Subject: Indian Point 3 Nuclear Power Plant
Docket No. 50-286
Environmental Qualification of Auxiliary
Feedwater System Electrical Equipment

ATTACHMENT I
PROPOSED AFS MODIFICATION

Indian Point 3 Nuclear Power Plant
docket No. 50-286
August 1982

FIG. 2: CONCEPTUAL DESIGN FOR STEAM SUPPLY TO AFB TURBINE

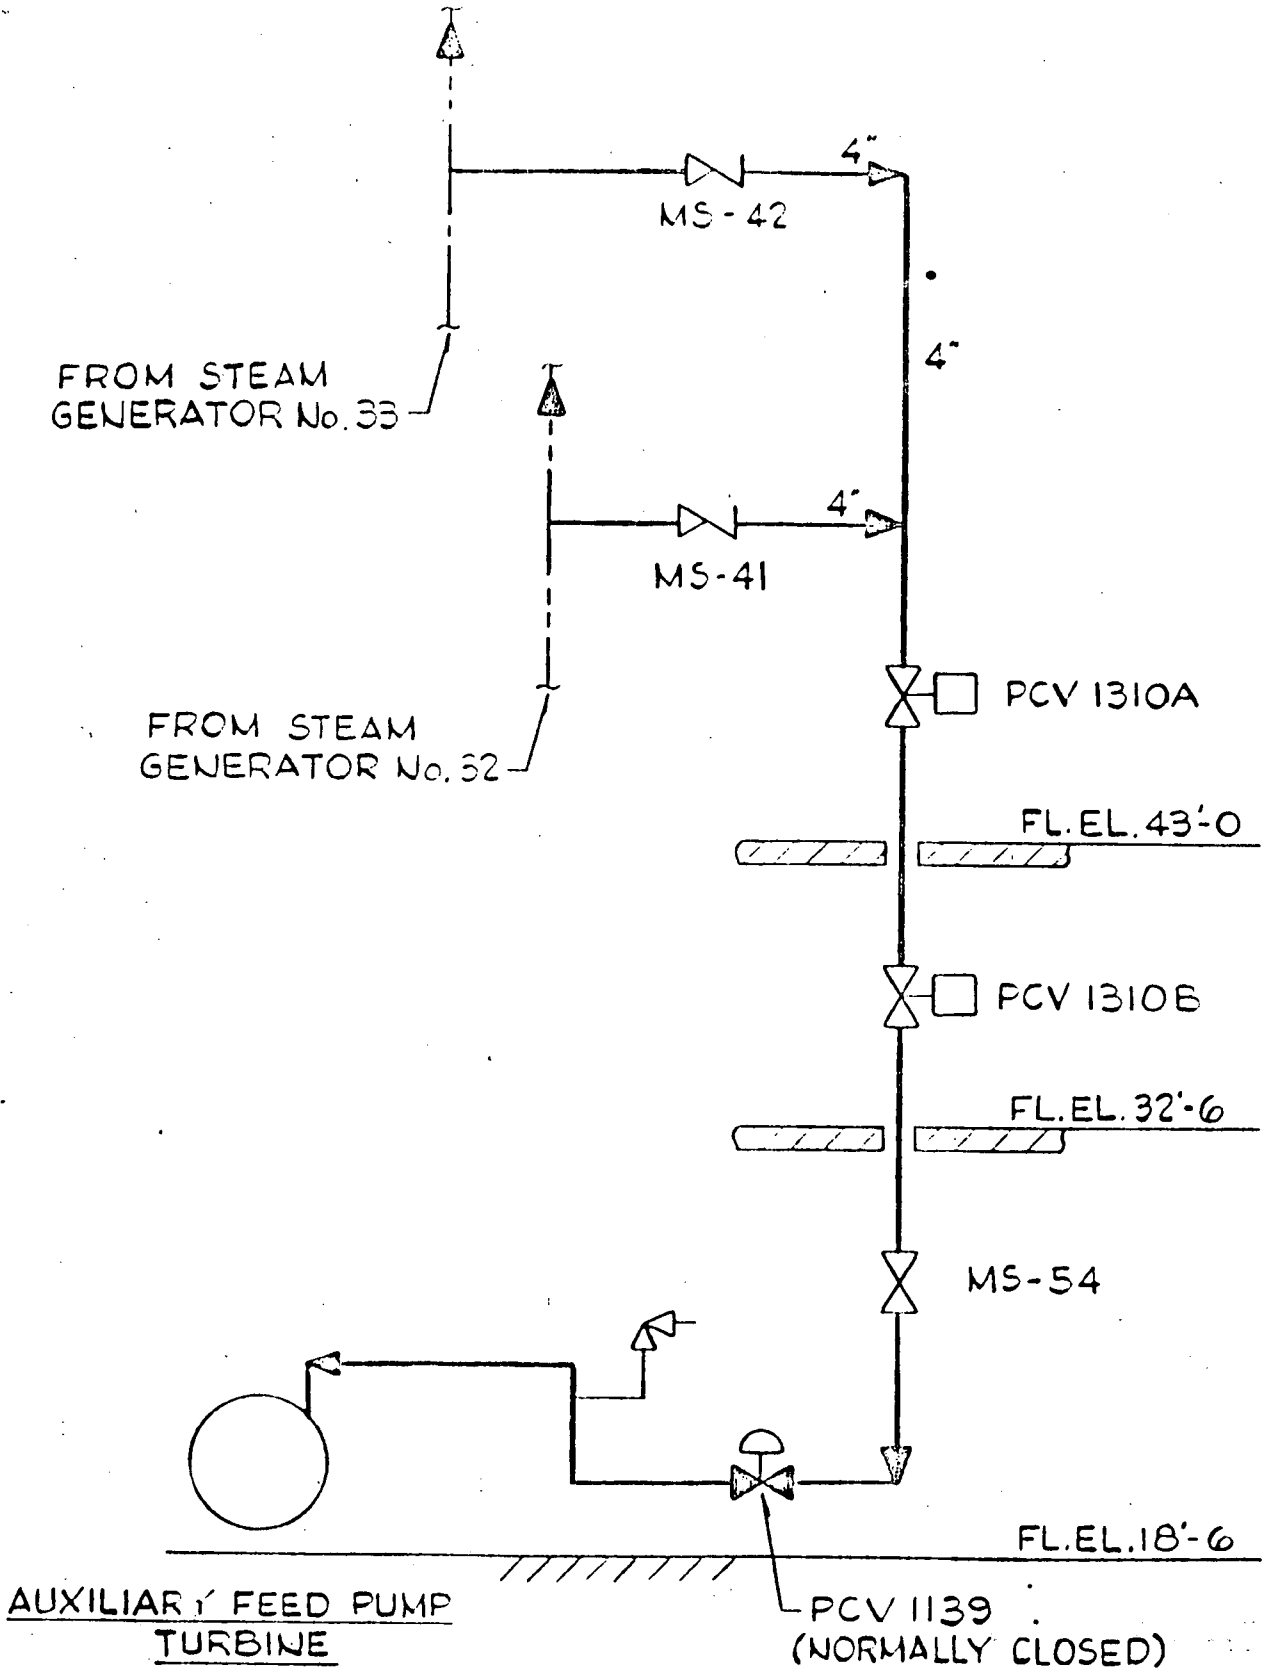
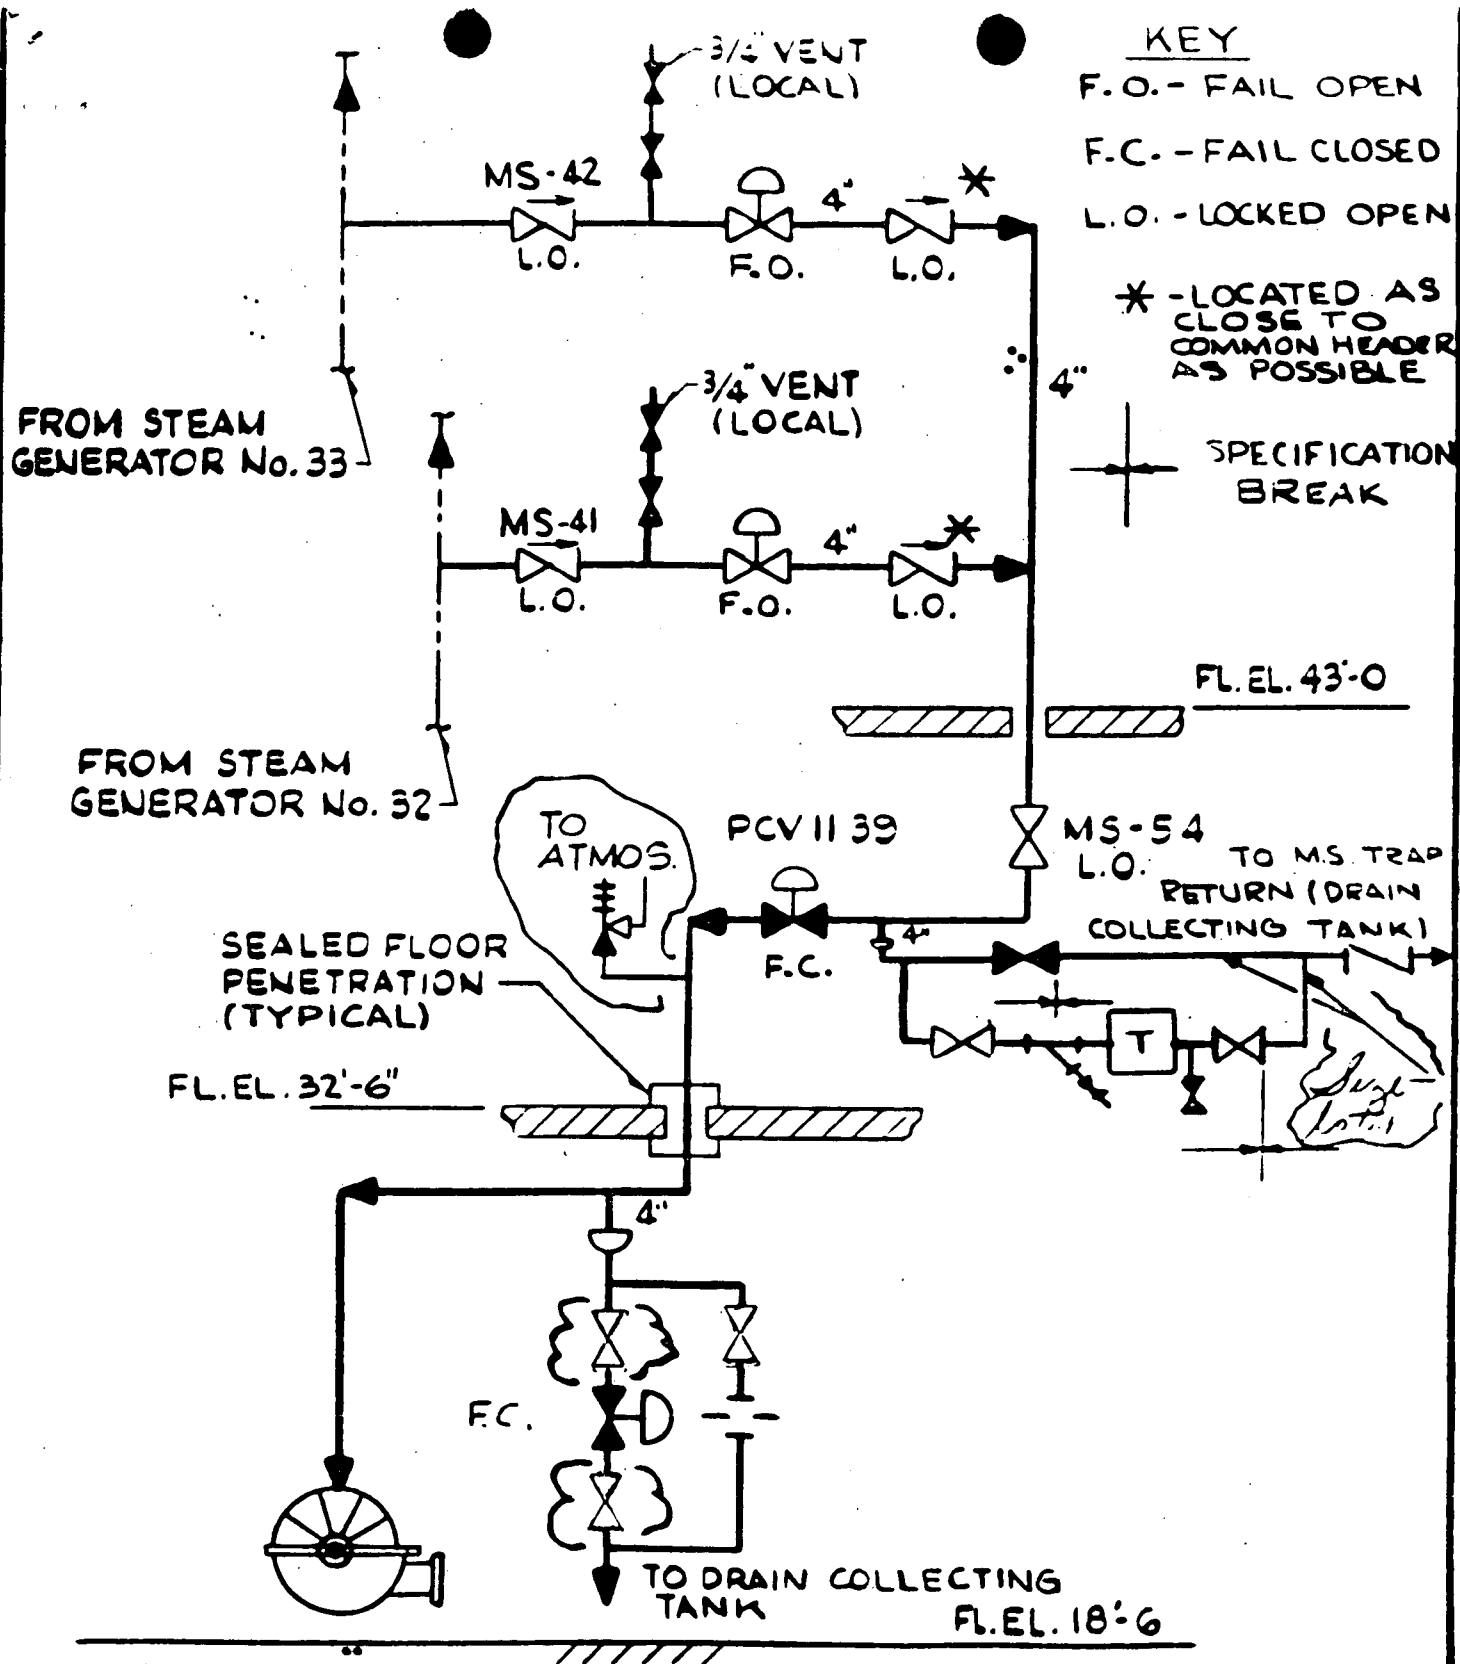
1. Add new air operated (with nitrogen backup), normally open, stop valves in each of the branch lines leading from the steam generators. The new stop valves will be added downstream of the existing stop-check valves (MS-41 and MS-42).

2. Add new stop-check valves downstream of the new isolation valves. Incorporate a normally closed vent downstream of the existing stop valves as a telltale for safety when maintenance is performed on the stop valves, and also for performing a hydro test of the line.

3. The new air operated isolation valves will be capable of remote manual activation from the control room and will also close automatically upon detection of a rupture in the common header. The preferable failure mode for the air operator will be "fail open" with an alarm to the control room.

4. Relocate the existing, normally closed, PCV-1139 and its associated manual isolation valve (MS-54) from the AFP room to the floor above (elevation 32'-6"), and seal the floor penetrations in the immediate location of the turbine driven steam supply line.

5. Remove the two existing, temperature actuated, shutoff valves (PCV-1310 A&B), as their function has been assumed by the new stop valves.
6. Add a drip pot and a continuous drain line upstream of the relocated valve PCV-1139 to prevent the accumulation of moisture due to the condensation of steam in the line.

7. Revise the piping layout downstream of the relocated PCV-1139 to improve drainage capability. The line shall slope continuously toward the turbine. The line shall also incorporate drip pots to aid in condensate removal.

8. Perform stress analysis in order to establish pipe support locations and to verify that the line downstream of the relocated PCV-1139 can accommodate the thermal and cyclic stresses imposed when PCV-1139 opens, or when either or both of the new isolation valves operate.
